Bid 627
New HVAC Modernization Project for (Both) Oxnard and Pacifica High Schools

BID CLARIFICATION ADDENDUM #3

Dated: August 25th, 2020

DRAWING NUMBER: **FAF2.1**

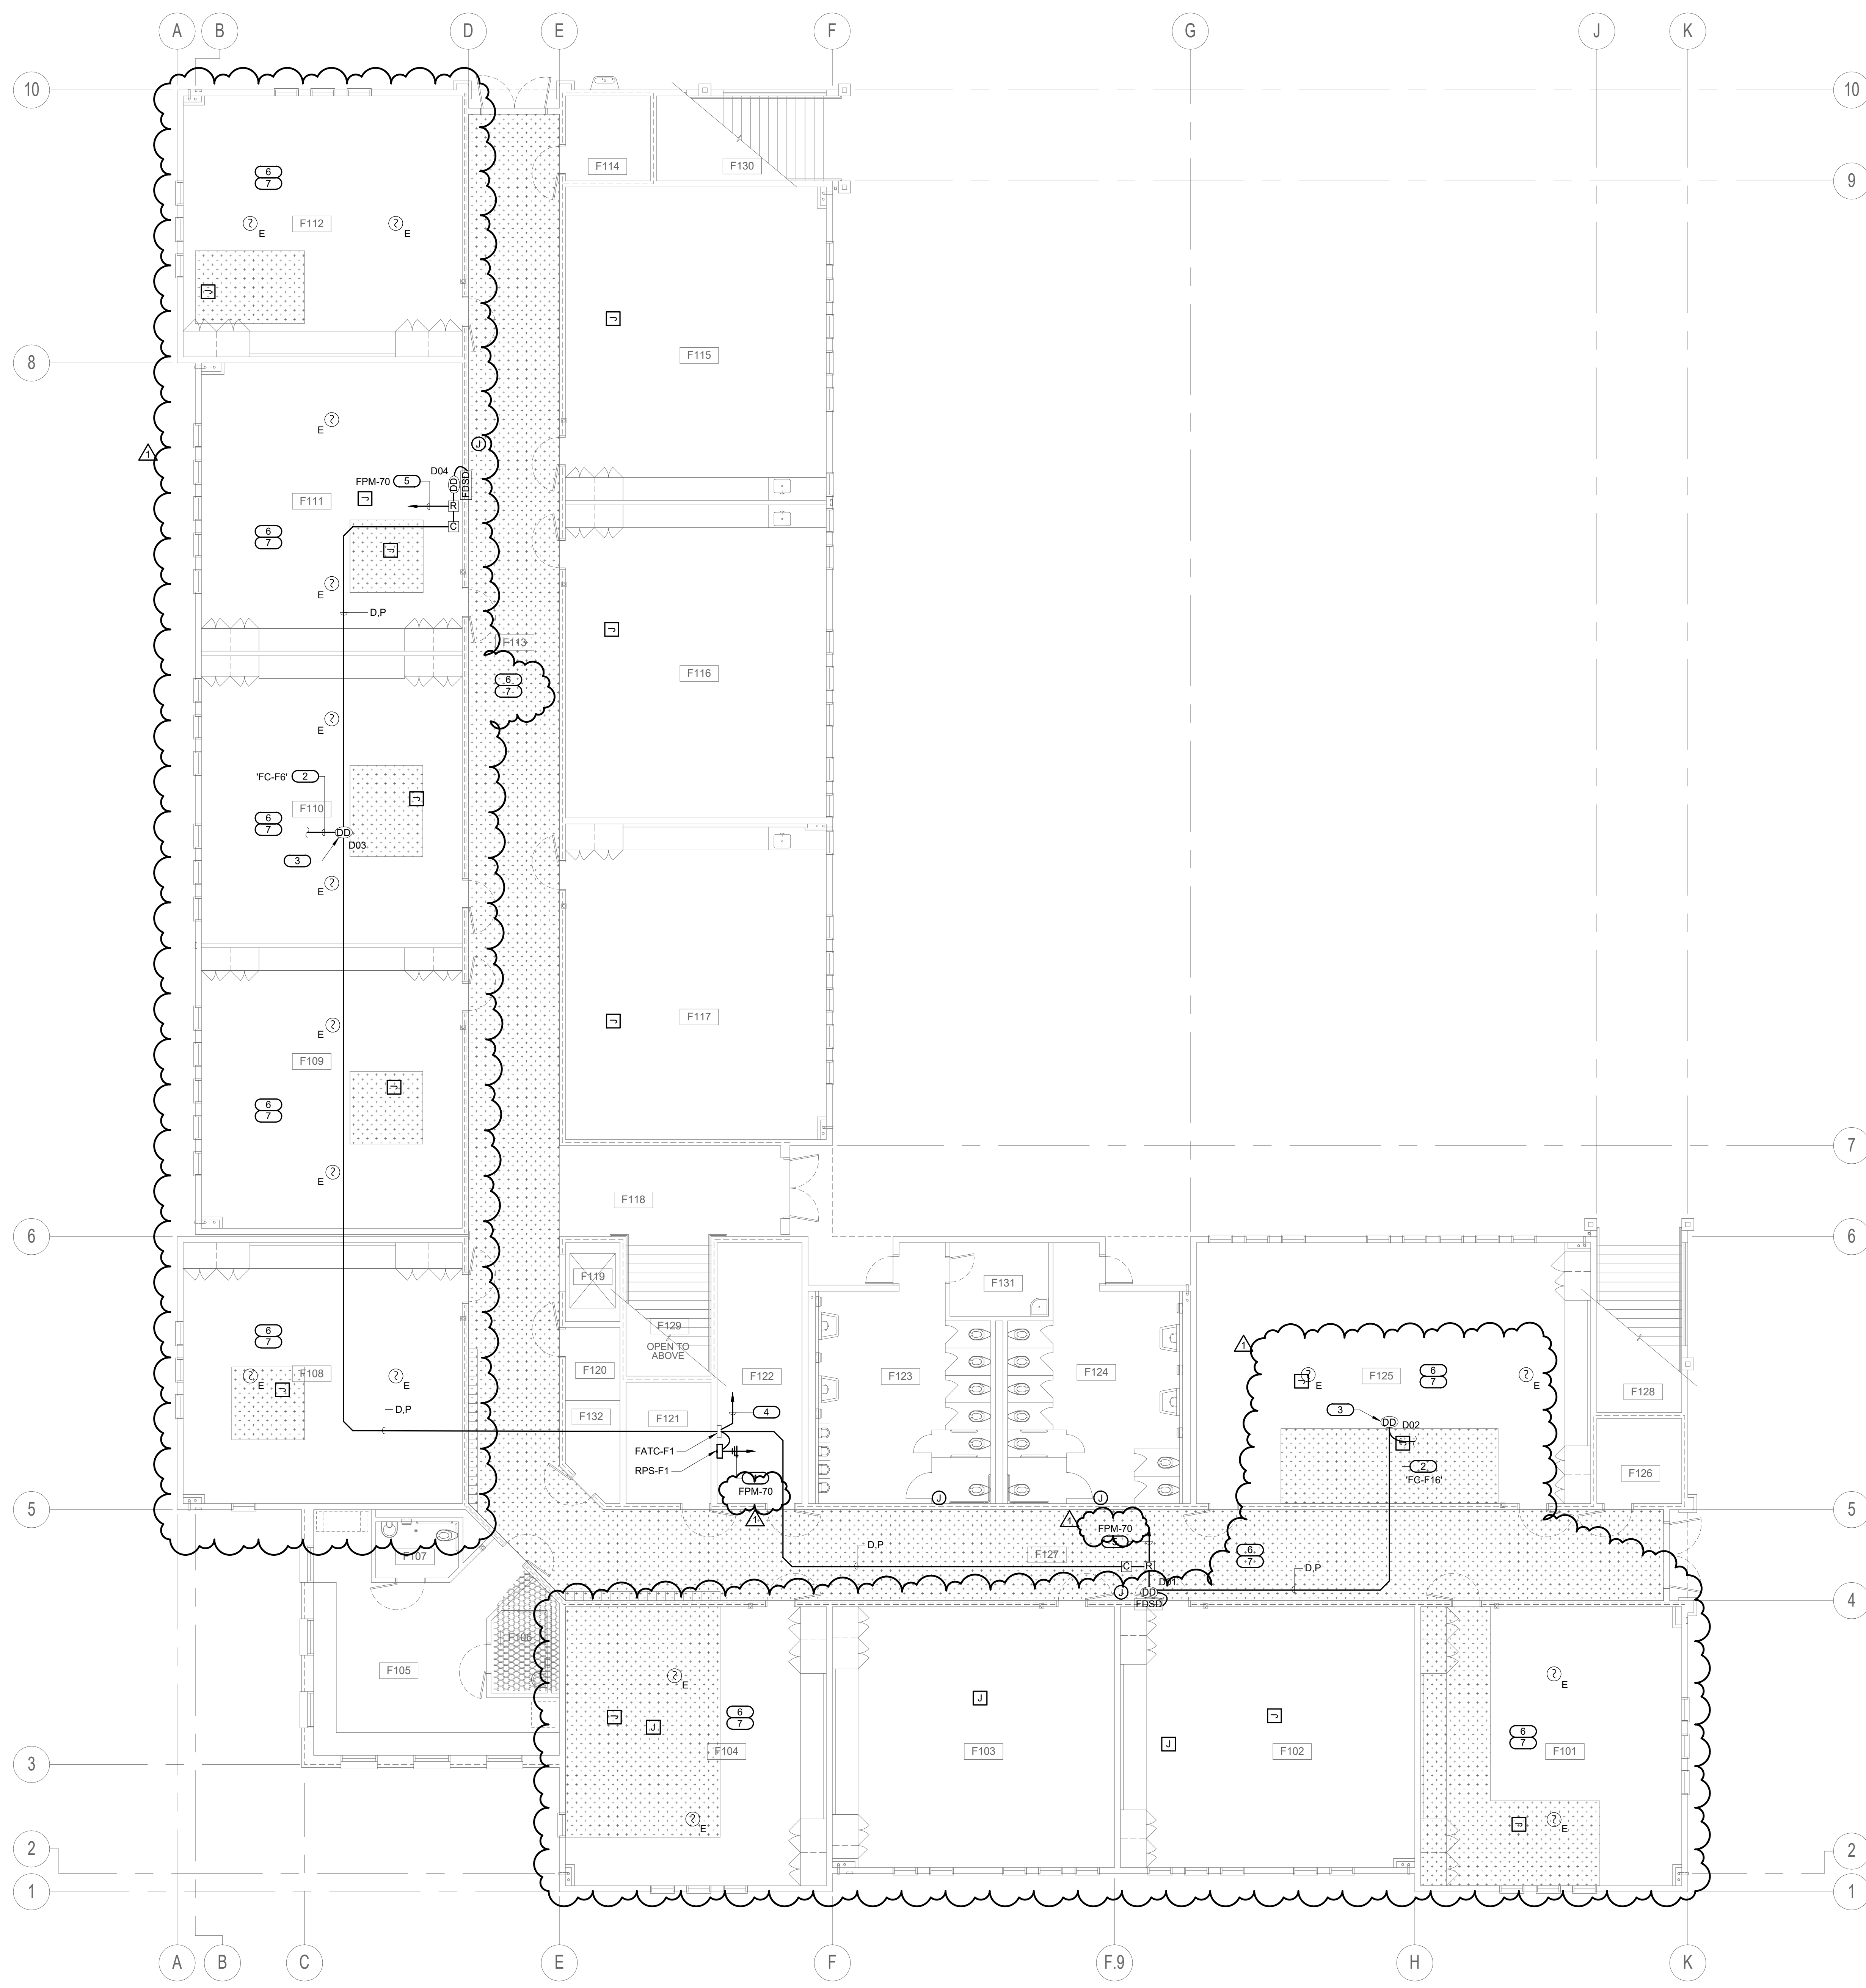
- A. Replace Drawing FAF2.1 in its entirety with attached Drawing FAF2.1.
 - 1. KEYED NOTES
 - a. Added Keyed Notes 6 and 7 pertaining to removal and re-installation of acoustical ceiling tiles.
